CONSULTATION MATERIALS

Prepared for the Havasupai Tribal Council Members

Arizona Department of Environmental Quality

Responses to questions received during consultation on April 24, 2026

Cone of Depression and Site Map

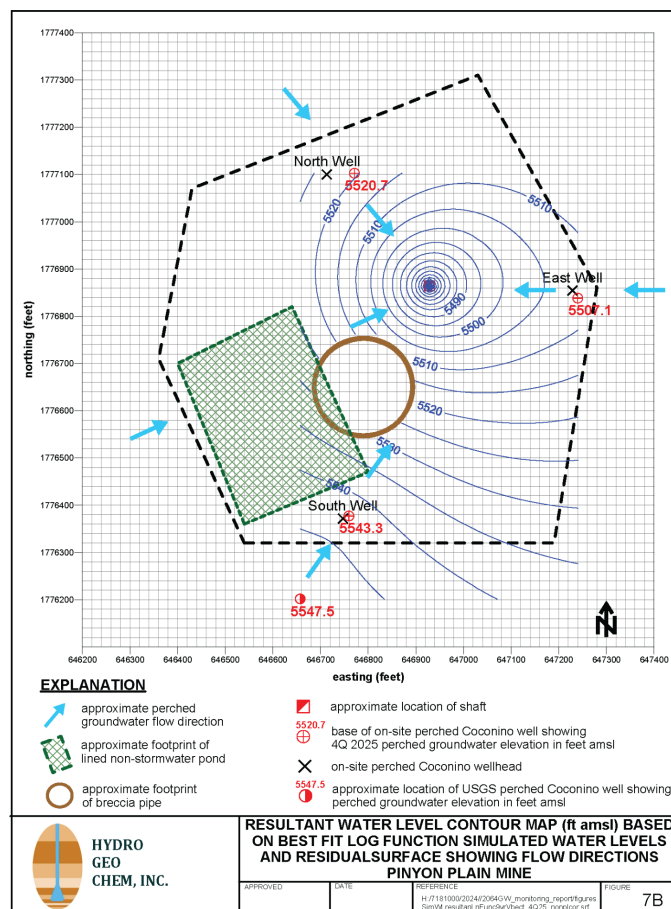
Question: Provide the distance and depth of the 3 perimeter monitoring wells in relation to the mine shaft.

ADEQ uses three point of compliance (POC) monitoring wells to monitor the groundwater conditions in the Coconino aquifer around the facility. The three POC wells are each located within approximately 500 feet of the mine shaft. Geologists verified the distances using surveyed drill hole measurements. Listed below are the three POC wells approximate distance from the mine shaft and depth.

- The East Coconino well (POC #1) is approximately 300 feet from the shaft and is 1,145 feet deep.
- The North Coconino well (POC #2) is approximately 305 feet from the shaft and is 1,130 feet deep.
- The South Coconino well (POC #3) is approximately 485 feet from the shaft and is 1,148 feet deep.

The permit also includes a fourth POC well — the Redwall-Muav well (POC #4) — which also serves as the facility's water supply well. It is located approximately 280 feet from the shaft and is 2,960 feet deep. Cement seals the well from the ground surface to 2,380 feet below ground surface to prevent water from moving between the two separate aquifers beneath the facility.

The Pinyon Plain Mine Fact Sheet includes a site map showing the locations of the Coconino monitoring wells, the mine shaft, and the breccia pipe which contains the ore body.

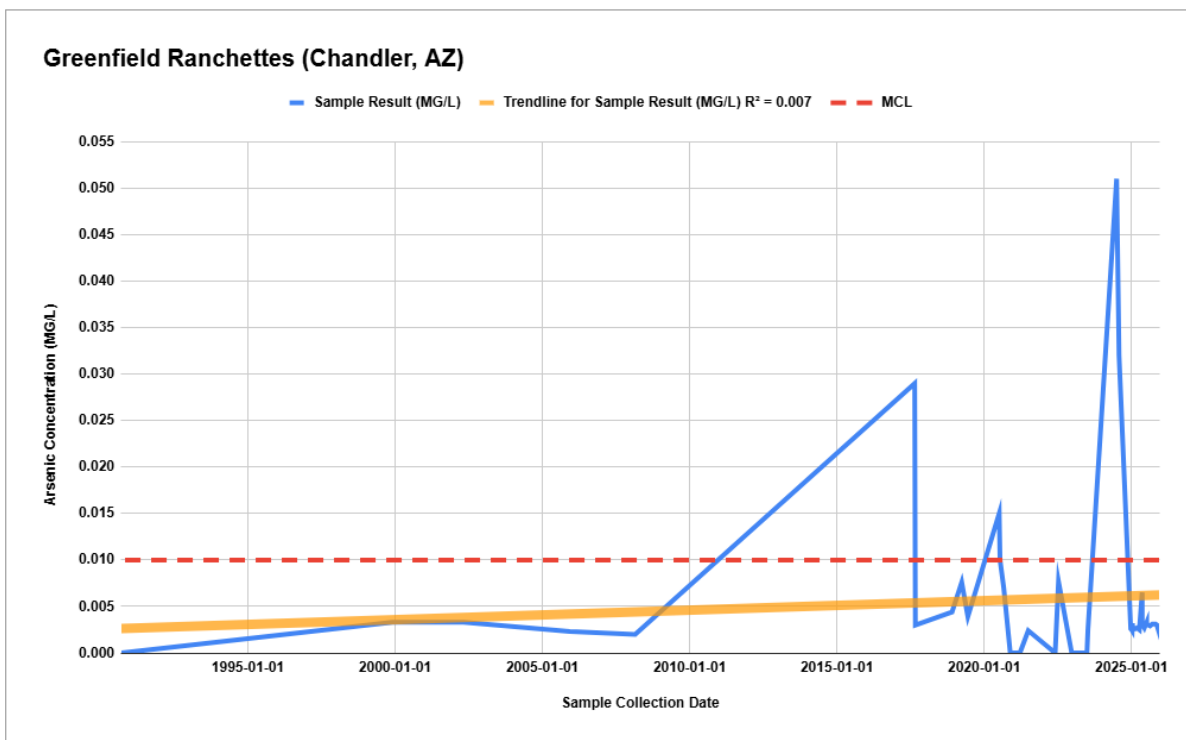
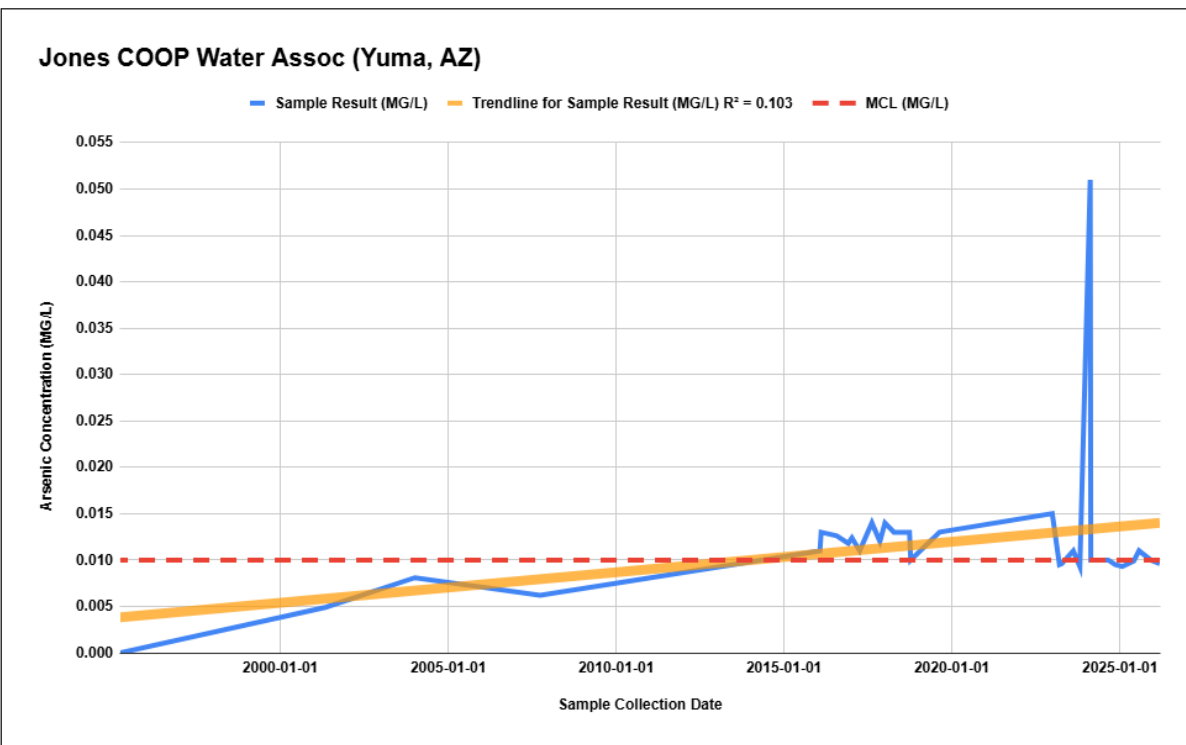
Question: The calculation for the adjusted standard should include the high outlier sample, even though the inclusion will result in a permit with a higher and less protective standard.

ADEQ understands the Havasupai Tribe's request to include all data in the calculation. However, ADEQ's statistical review found that one sample result was significantly different from the rest of the groundwater data collected at the site and was not representative of normal groundwater conditions and was not repeated with a verification sample or samples collected since that time.

Including the outlier would increase the permit limit to 0.2 mg/L, which is more than four times higher (400%) than the current limit of 0.05 mg/L. By comparison, the current application requests an increase of about 10%.

To remain consistent with the U.S. Environmental Protection Agency's statistical procedures and ADEQ's mission to protect human health and the environment through science-based regulation, ADEQ removed the outlier and used the lower, more conservative and protective limit calculation.

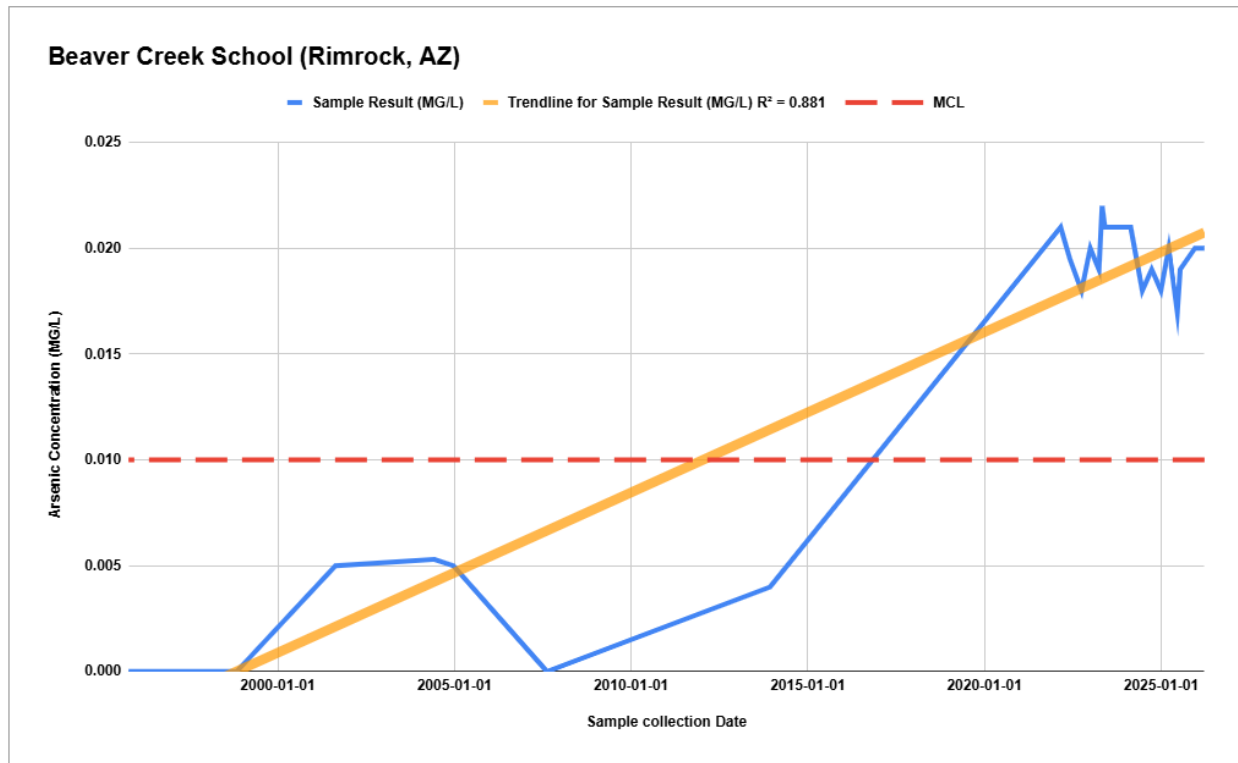
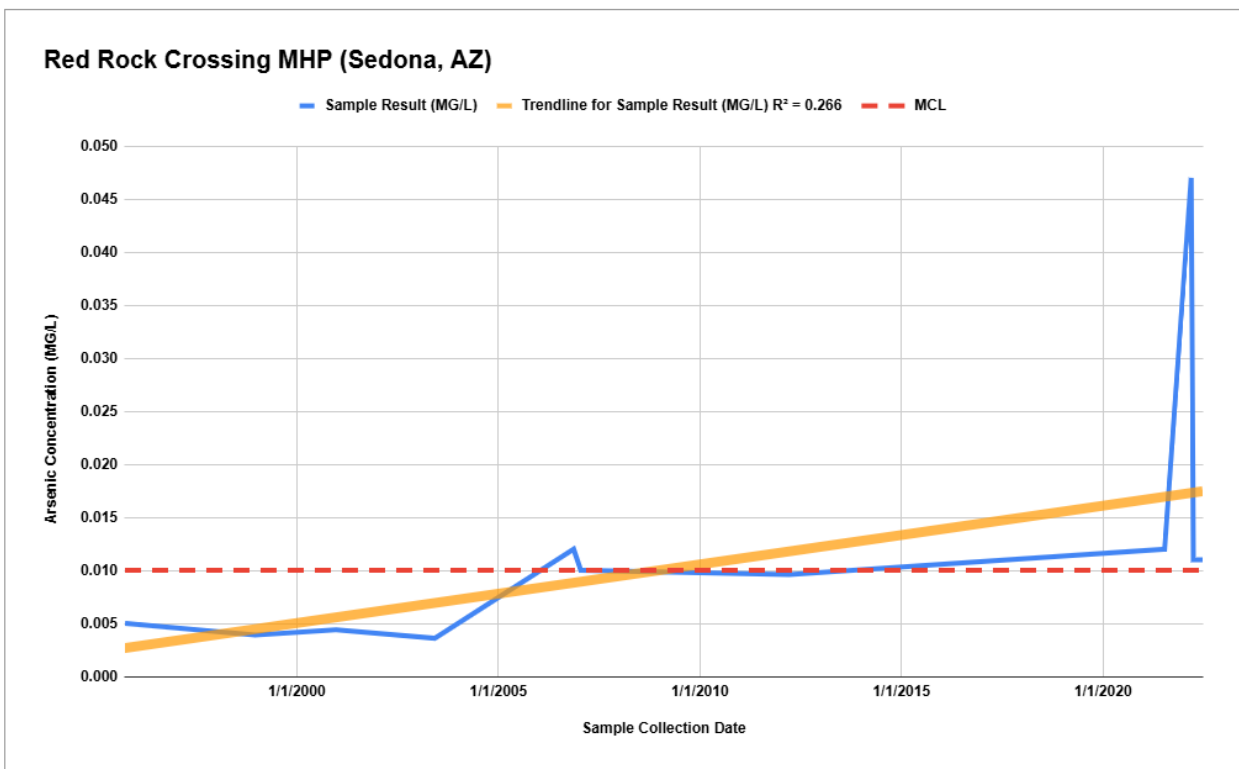
Question: This permit action should be considered as an “other” amendment instead of a “minor” amendment.

The current permit allows the company to submit technical information showing that an Alert Level (AL) exceedance was caused by natural conditions rather than a discharge from the facility. EFRI submitted technical information and laboratory data to support its request.

Arizona Administrative Code (A.A.C.) R18-9-A211(C)(7) defines this type of permit change as a minor amendment when the original permit already established the method for calculating alert levels or permit limits.

Because criteria for calculation of ALs is established in Section 2.5.3.3 of the permit, this permit action is a minor amendment.
